Final Value Analysis Study Report

Davis Road Bridge Replacement

February 2017

Subject: Final VA Study Report (Task Order 238)
Davis Road Bridge Replacement Project

VA ALTERNATIVE 9.0

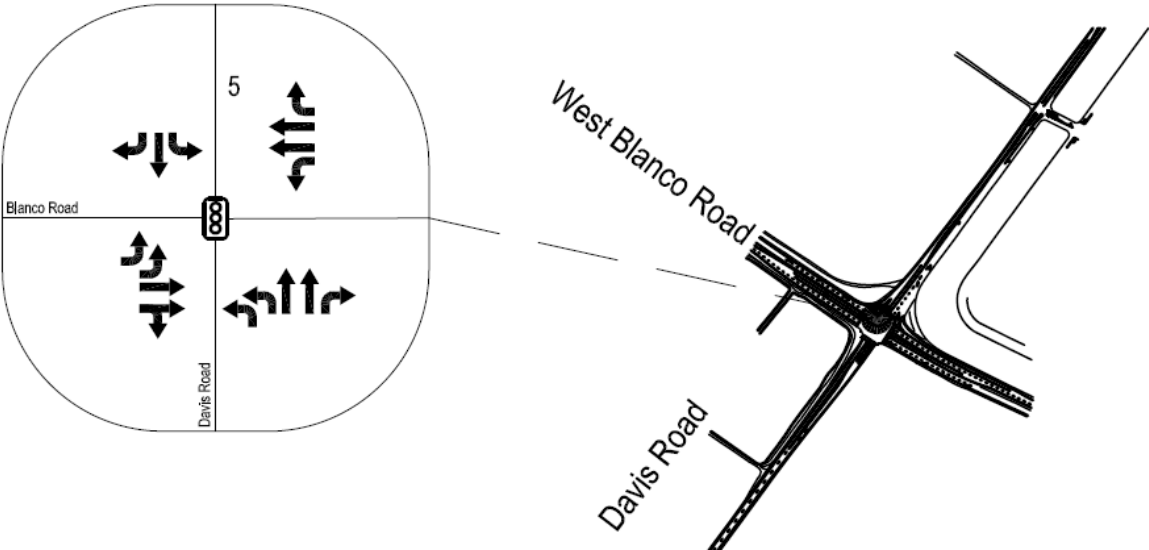
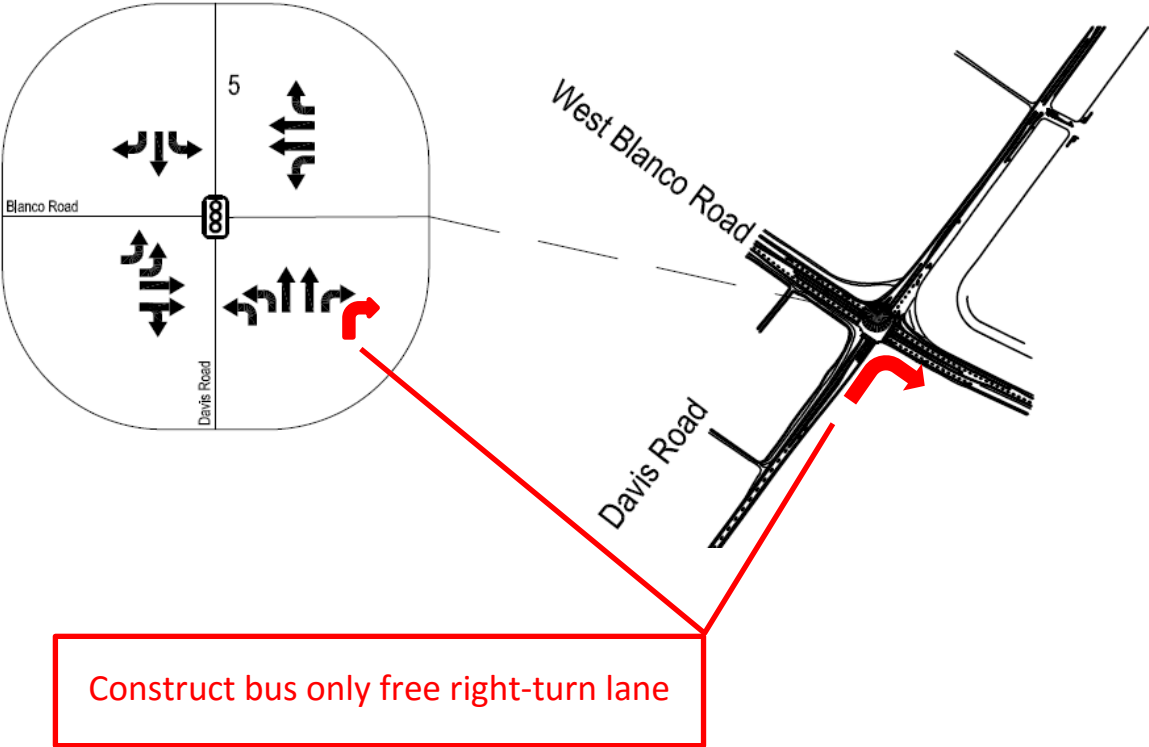
The alternative concept would add a bus-only free right-turn lane at northbound Davis Rd. to eastbound Blanco Rd., making bus travel faster by minimizing delays at this intersection. Bus operations would improve, but will require additional right-of-way take and land mitigation.

Add a free-flow right-turn at SB Davis Rd. to WB Reservation Rd.

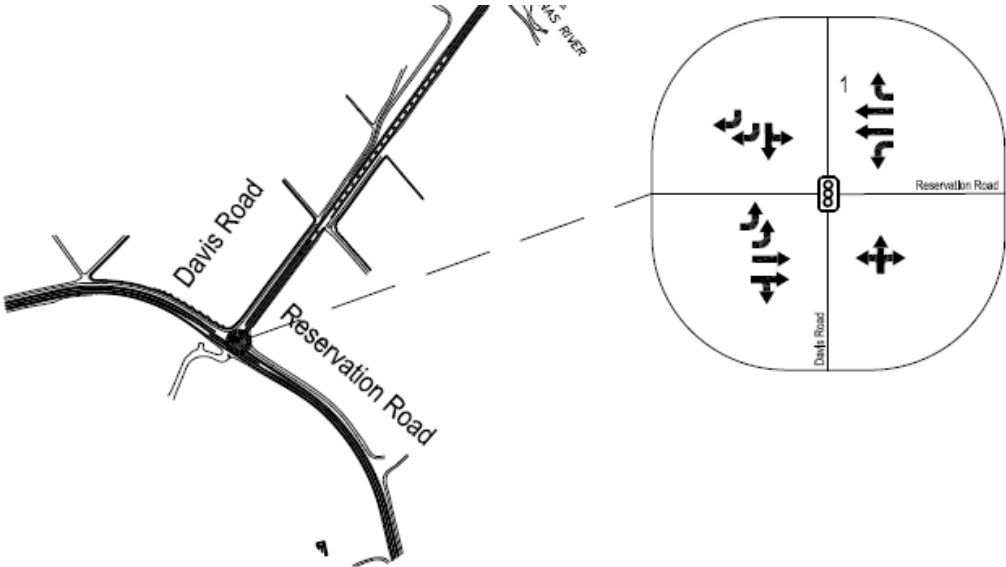
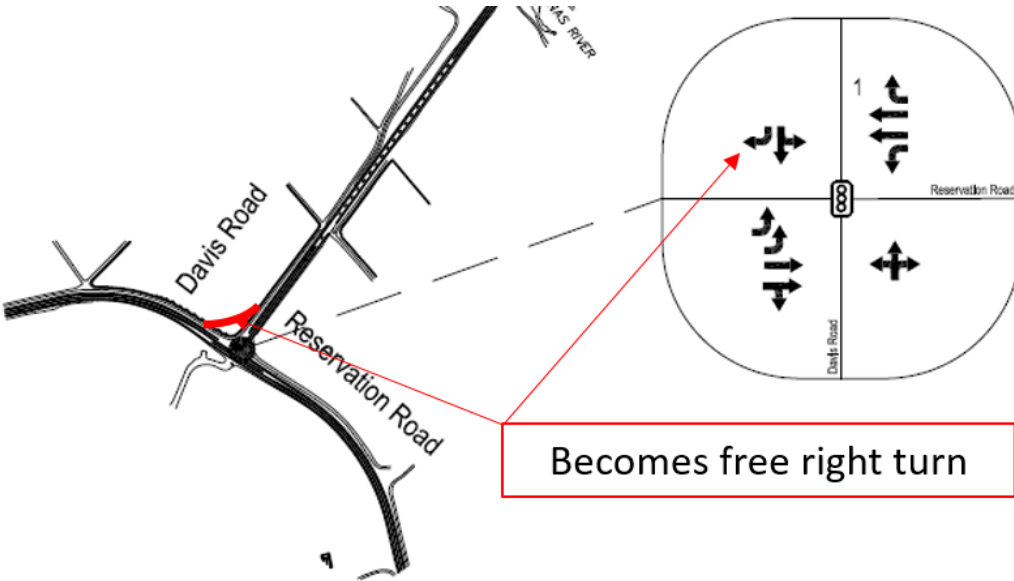
This alternative would have a substantial impact on the agricultural property located on the northwest corner of the Reservation Road and Davis Road intersection. There are plans for future development on this corner that would also be impacted. It was also determined that traffic operations would not be improved enough to justify this alternative because of the high volumes travelling both westbound and eastbound on Reservation Road to northbound on Davis Road.
